# Integration of the cryogenic line

Meeting minutes, 17/8/2016

## 617 zone (crab-cavity test stand)

Figure 1 The U on the two raw water pipes at the tunnel vault is on top of the future crab cavity zone.

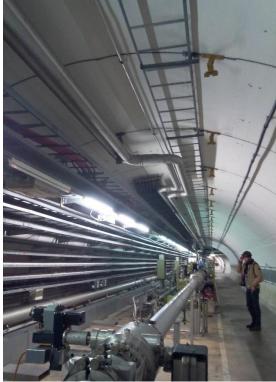
<u>Removal or displacement of the Omega</u> on the 2 (raw) water pipes at the tunnel vault, requested by TE/CRG. See Figure 1 and 2. Without this and the cable tray, the warm pipes for cryogenics could be integrated inside the U-support of the cryogenic distribution line.

P.Pepinster thinks it is not a thermal dilatation compensator, as the raw water temperature is not very much different from ambient and varies in a small range. He will check the necessity of this Omega with B.Bannister and confirm whether it can be removed. (Action EN/CV)

Figure 4

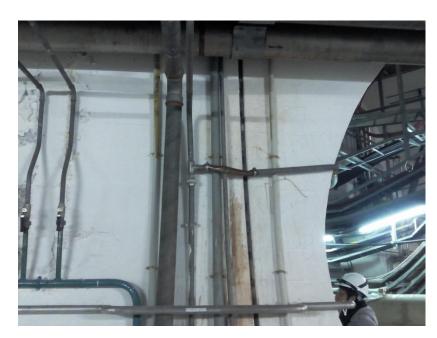
GV asks that the feet of the cryoline supports are in the wall curb, even if this requires angled or curved mounting brackets. The impact on the floor must be null, to ensure quick approval of the underground

infrastructure modification. Displacement of the cryoline by 20cm towards the wall requires verification with the 3D optical scan and possibly on site for smaller components which the scan may not show precisely. The difficulty may come from pipework and manifolds at the entrance of the tunnel (see Figure 4) (Action GV to ask for a very short access / Action EN/ACE to verify with the 3D scans)
